SERVICETEKNOTES

Published by Tektronix
Service Publications

TABLE OF CONTENTS

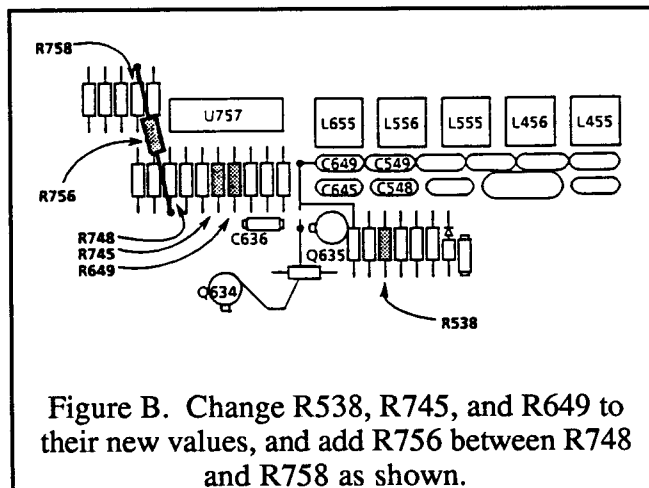
In order to more closely match the timing and SCH phase of the Black Burst output to that of the Test Signal output, a number of changes were made to the A3 Analog Board.

1. A circuit board trace was cut as shown in Figure A.

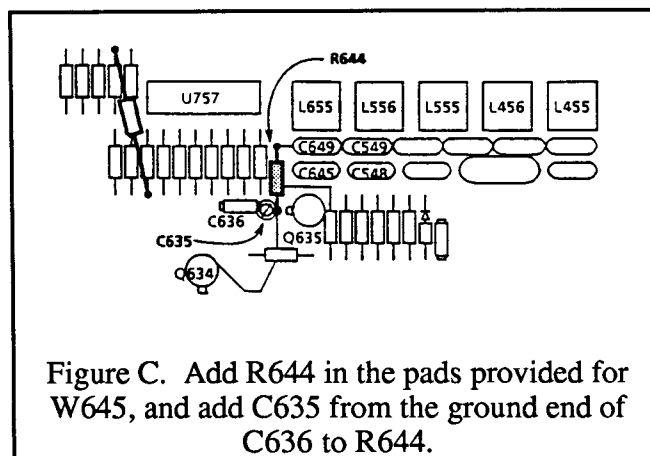
2. A3R538 was changed to 200 ohms, P/N 321-0126-00.
3. A3R745 was changed to 150 ohms, P/N 321-0114-00.
4. A3R649 was changed to 10 ohms, P/N 321-0001-00.
5. A3R756, 10.0 K ohms, P/N 321-0289-00 was added as shown in Figure B.

Fig. 1

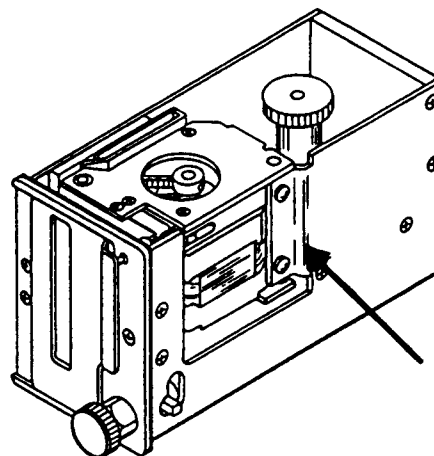
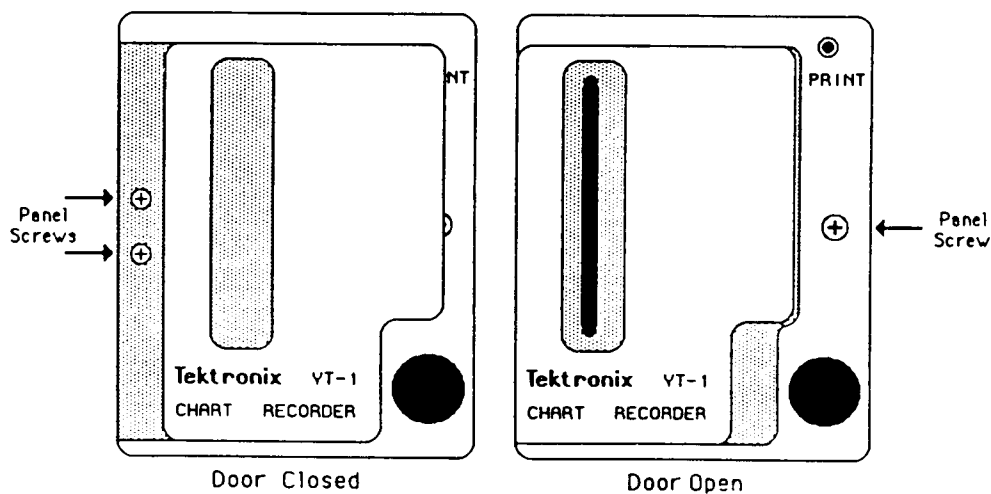
The problem is occurring in older YT-1's because of insufficient space between the Paper Roller and the Controller board. The bottom of the Paper Roller can touch a pad on the Controller board, shorting the +5V power supply to ground. This problem was fixed in YT-1's made after June of 1988 by a change to the frame, allowing more space between the roller and board. Refer to Figure 1 to identify Old/New style frames.

Fig. 5-20. Equipment connections for adjusting PIX MON OUT flat response.

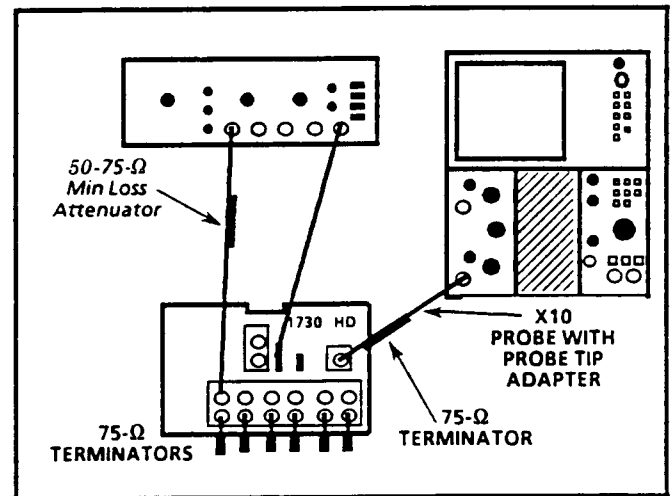
Step 19. Adjust X5 Flat Response

- a. Select ONE FIELD, CH1A, AND X5 Gain on the 1730 HD.
- b. Adjust the Sweep Generator amplitude for a 700 mV display on the 1730 HD.
- c. ADJUST — A3C842 (X5 Response) for the best flat response as viewed on the 1730 HD.
- d. Connect the Leveled Sine-Wave Generator to the 1730 HD CH1A INPUT.
- e. Set the Leveled Sine-Wave Generator frequency to 50 kHz and adjust its amplitude for a 700 mV display on the 1730 HD.
- f. CHECK — for flatness of $\pm 5\%$ (35 mV or 1.5 minor divisions) while varying the Leveled Sine-Wave Generator frequency from 50 kHz to 6 MHz.
- g. Repeat steps a. through f. for CH2A, CH3A, CH1B, CH2B, and CH3B.
- h. Remove all cables and terminators from the 1730 HD.

Fig. 5-21. Allowing a gap when installing right-angle square pins.

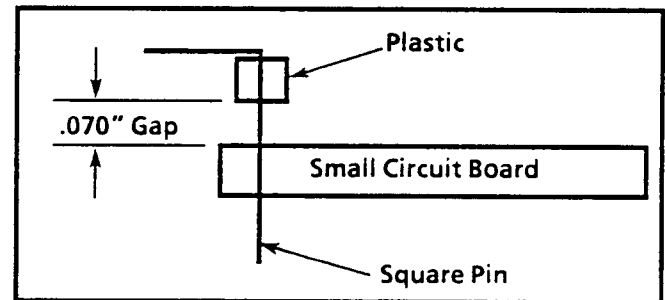
Step 5. Replacement small boards are shipped with right-angle square pins installed in the proper position. If a board is repaired rather than replaced, and new square pins are installed, a gap of .070" must be allowed between the plastic portion of the square pin and the small circuit board, for purposes of fit.

Fig. 5-1. REMOTE connector modified for Remote Sync input.

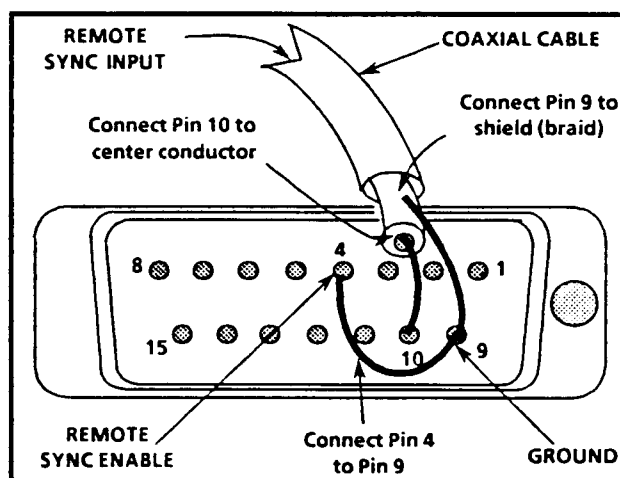
15-pin, sub-miniature, D-type connector modified to enable and input Remote Sync. See Fig. 5-1.

Fig. 3-1. Color Bar signal components.

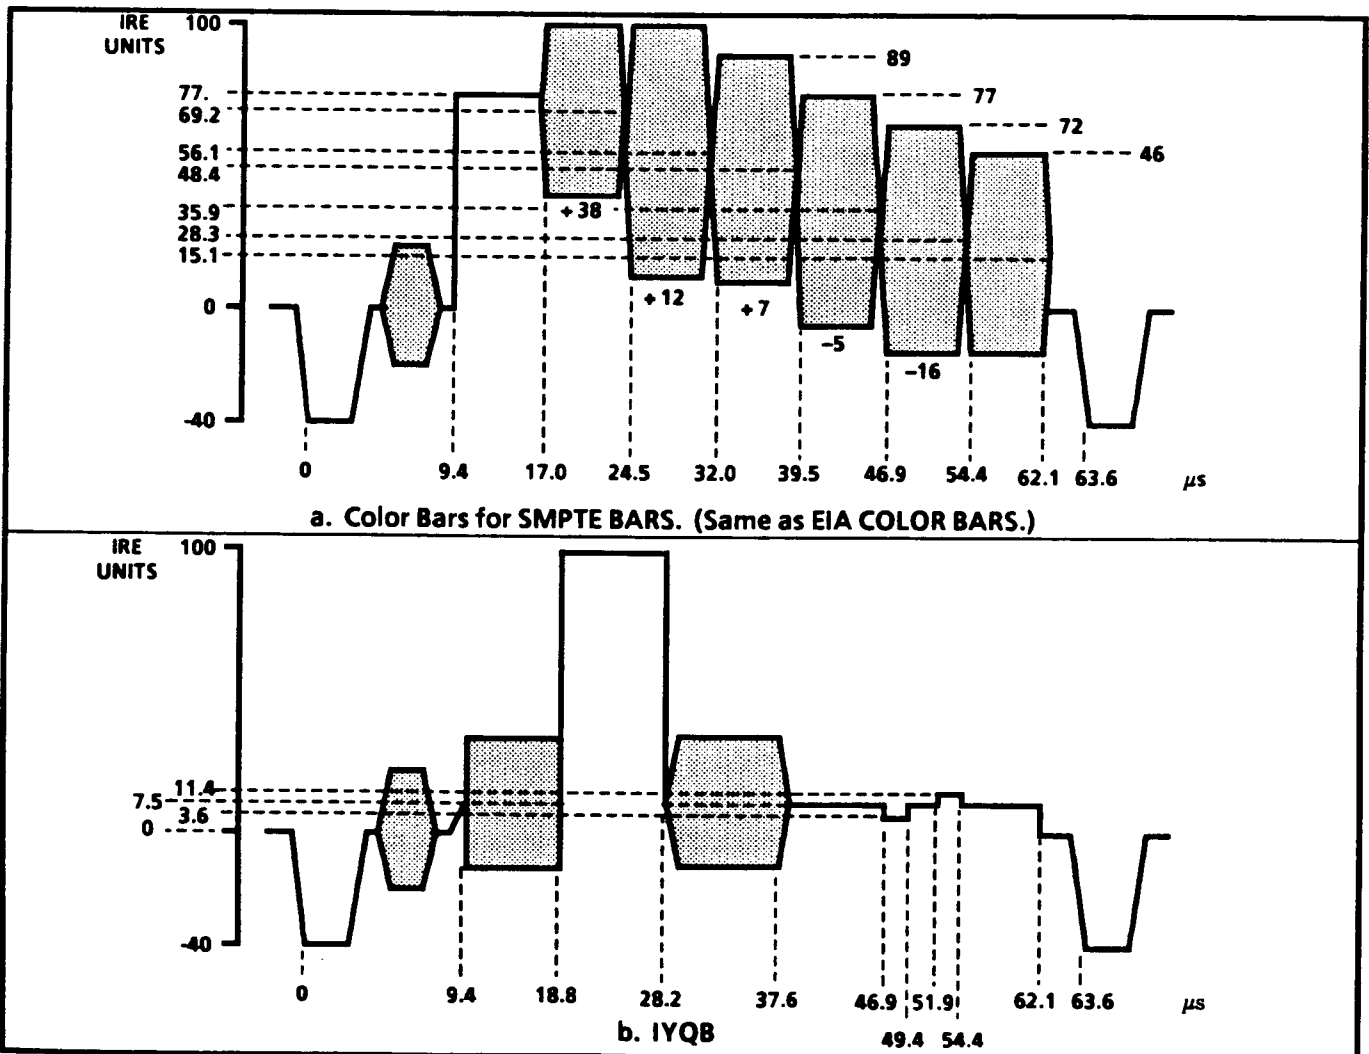
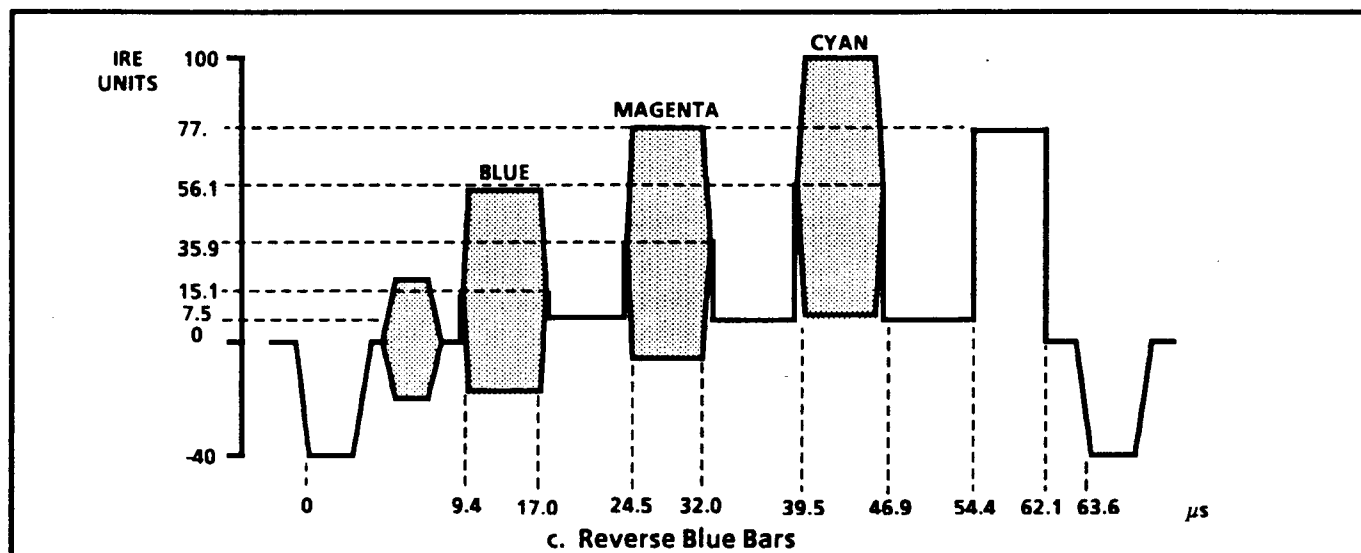
Page 3-6, Fig. 3-1. Color Bar signal components
 CHANGE Fig. 3-1 AS SHOWN:

Fig. 3-2a. Horizontal Component of Convergence test signal.

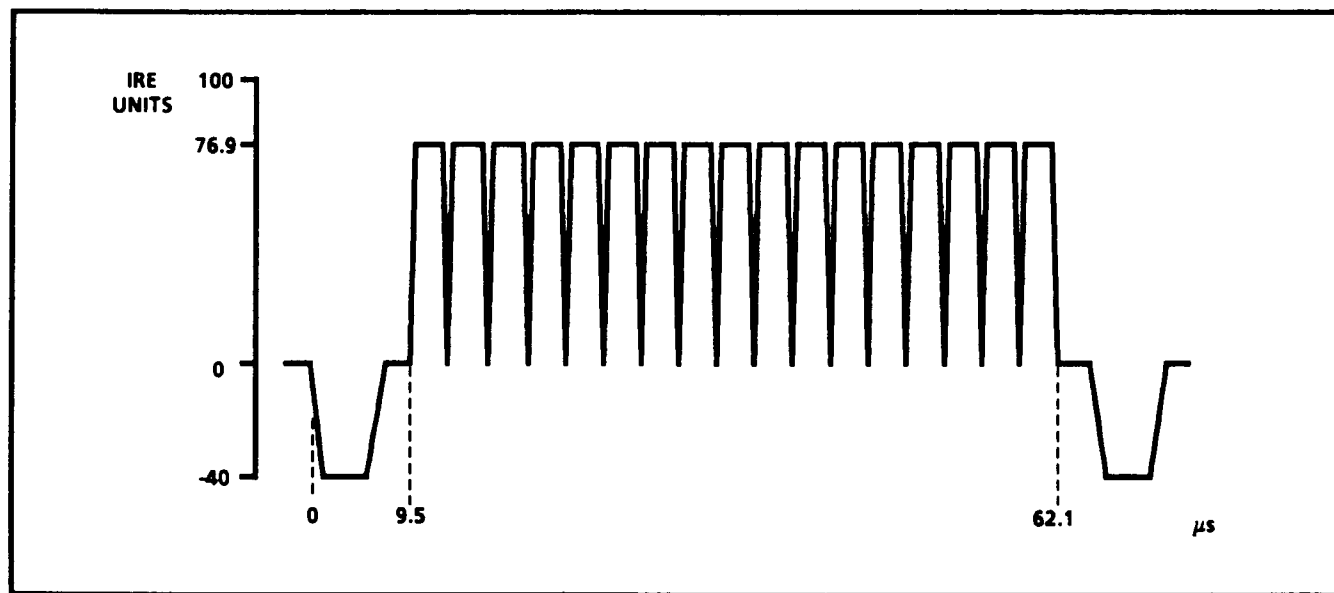
Page 3-7, Fig. 3-2a. Horizontal Component of Convergence test signal.

CHANGE Fig. 3-2a AS SHOWN:

Fig. 3-4. Multiburst.

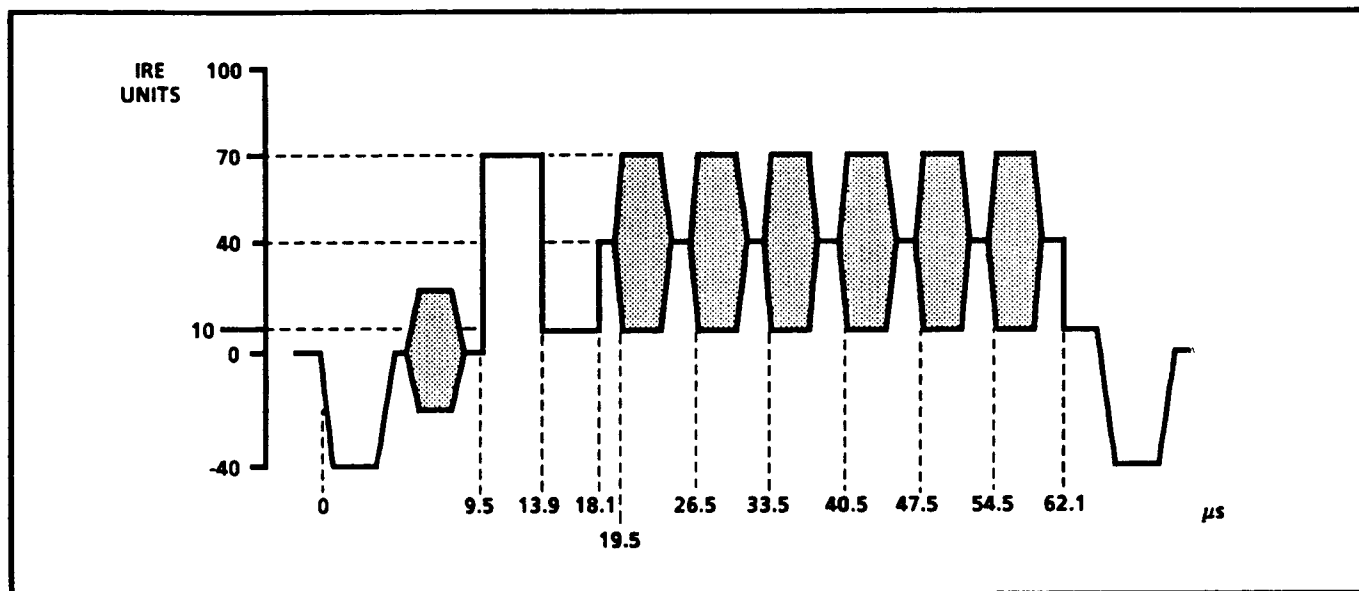
Page 3-8, Fig. 3-4. Multiburst
CHANGE Fig. 3-4 AS SHOWN:

Fig. 3-7. APL and Bounce.

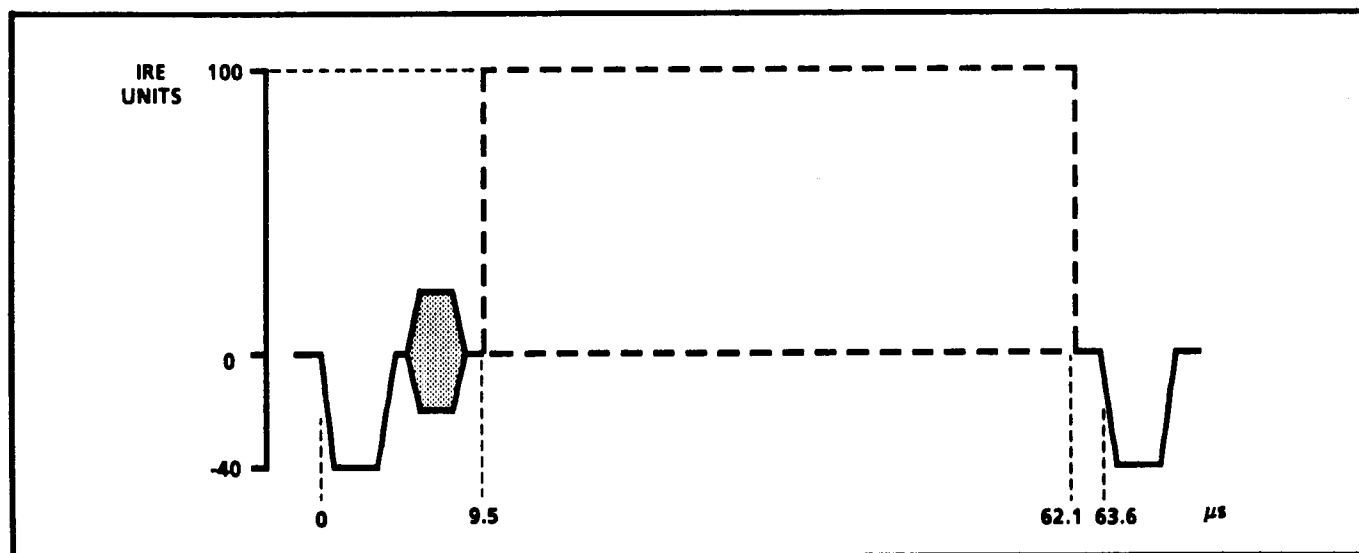
Page 3-10, Fig. 3-7. APL and Bounce
CHANGE Fig. 3-7 AS SHOWN:

Fig. 3-8. 100/10 IRE Flat Fields.

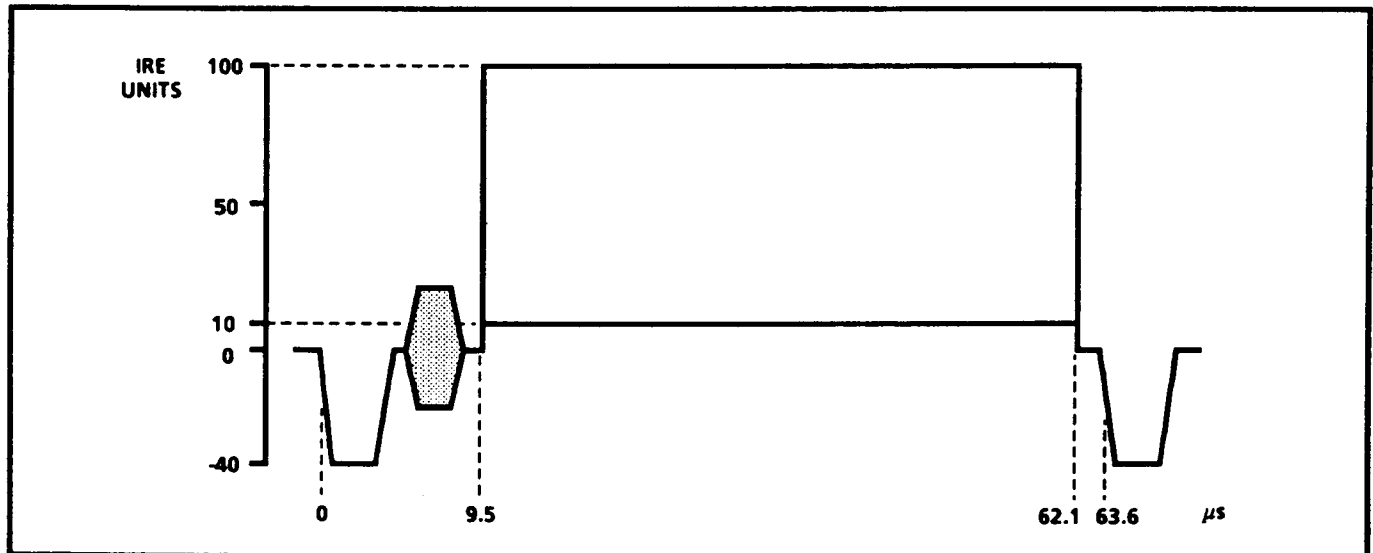
Page 3-10, Fig. 3-8. 100/10 IRE Flat Field
CHANGE Fig. 3-8 AS SHOWN:

Fig. 3-9. Red Field.

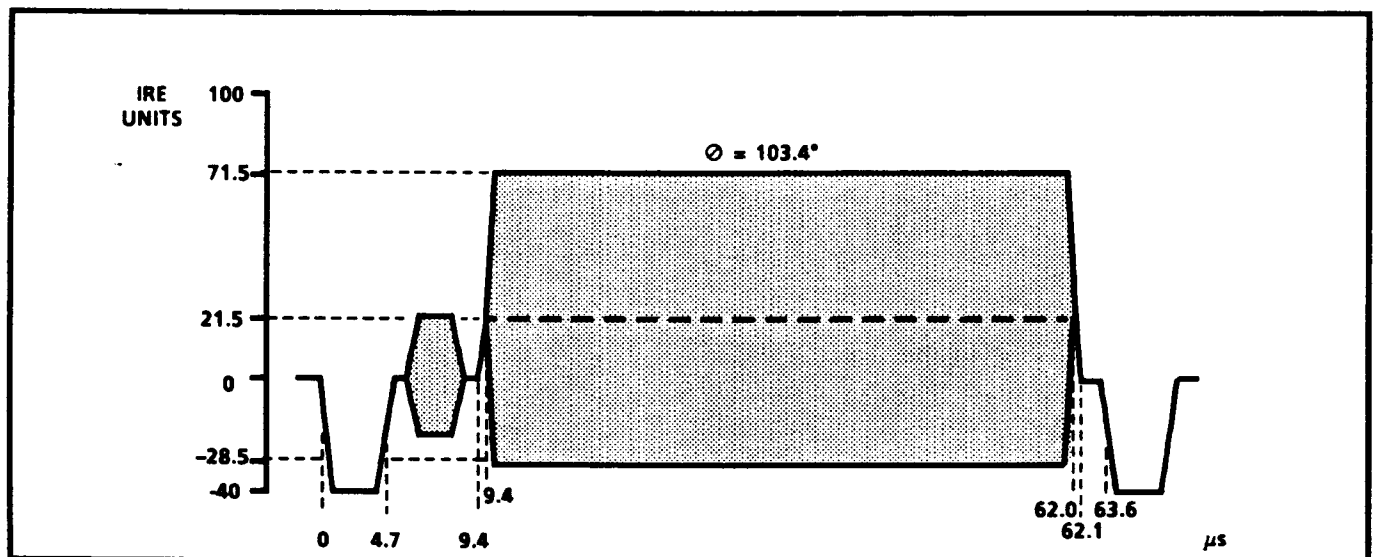
Page 3-11, Fig. 3-9. Red Field
CHANGE Fig. 3-9 AS SHOWN:

Fig. 3-10. Multibars.

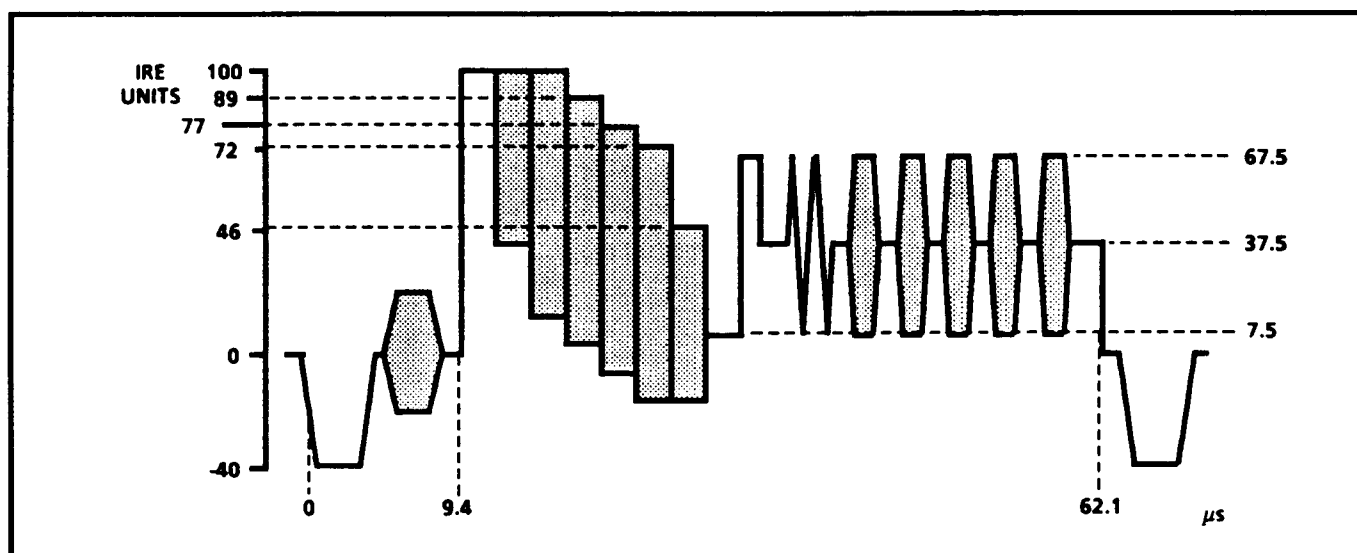
Page 3-11, Fig. 3-10. Multibars
CHANGE Fig. 3-10 AS SHOWN:

Fig. 3-12. Line Sweep with Markers.

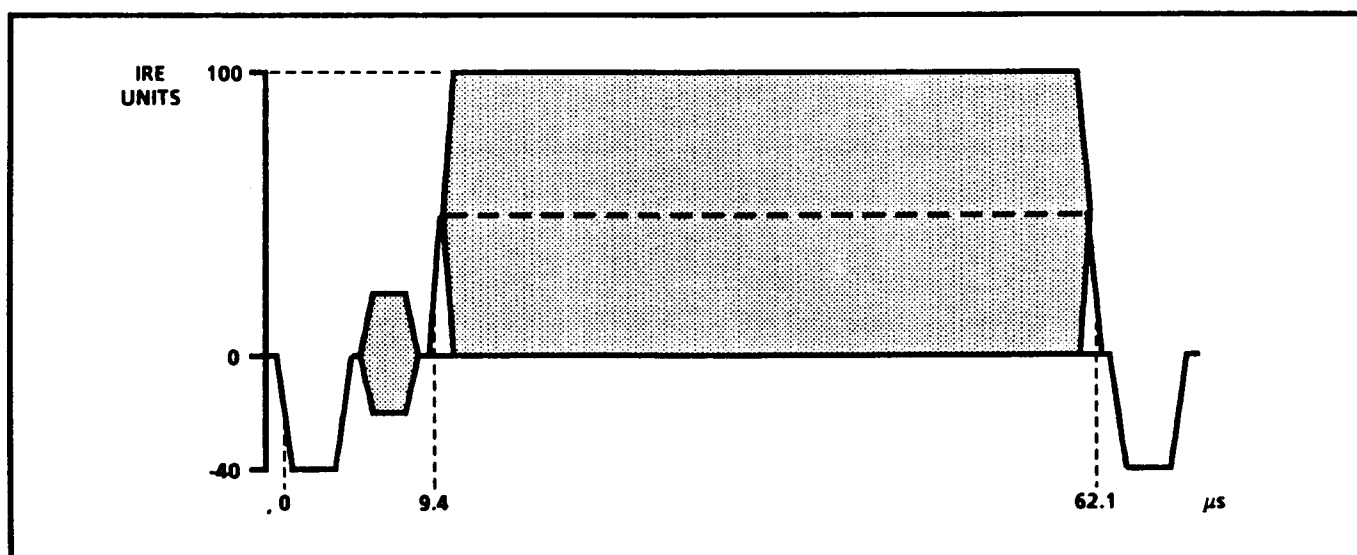
Page 3-12, Fig. 3-12. Line Sweep with Markers
CHANGE Fig. 3-12 AS SHOWN:

Fig. 3-13. Multipulse.

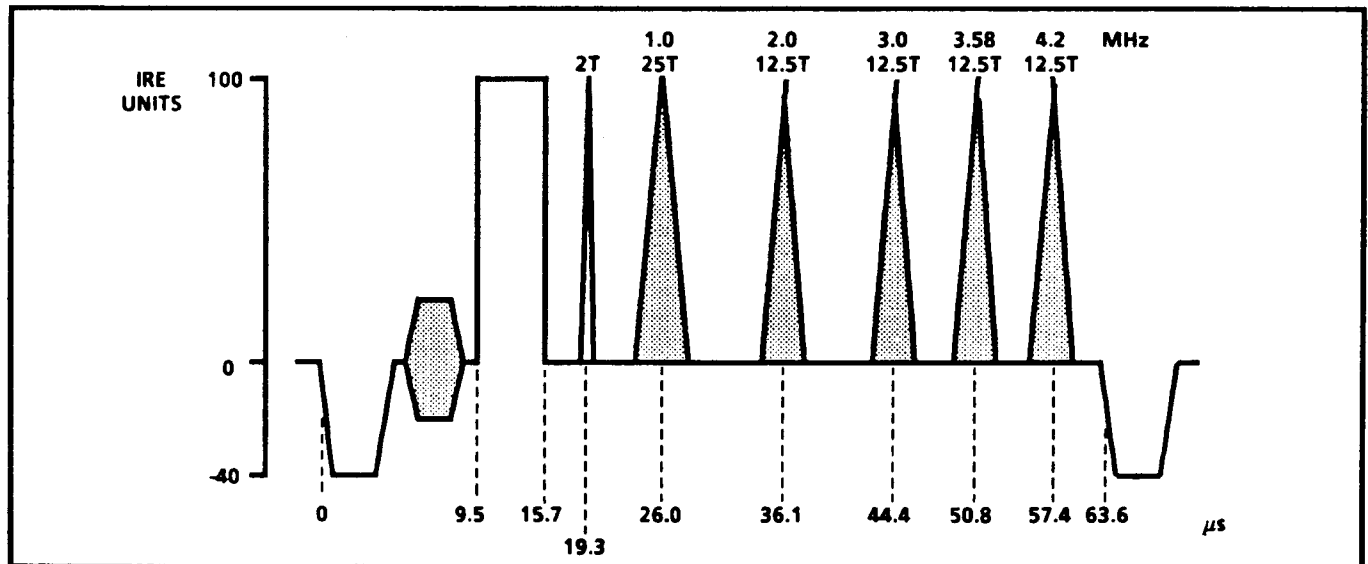
Page 3-13, Fig. 3-13. Multipulse
CHANGE Fig. 3-13 AS SHOWN:
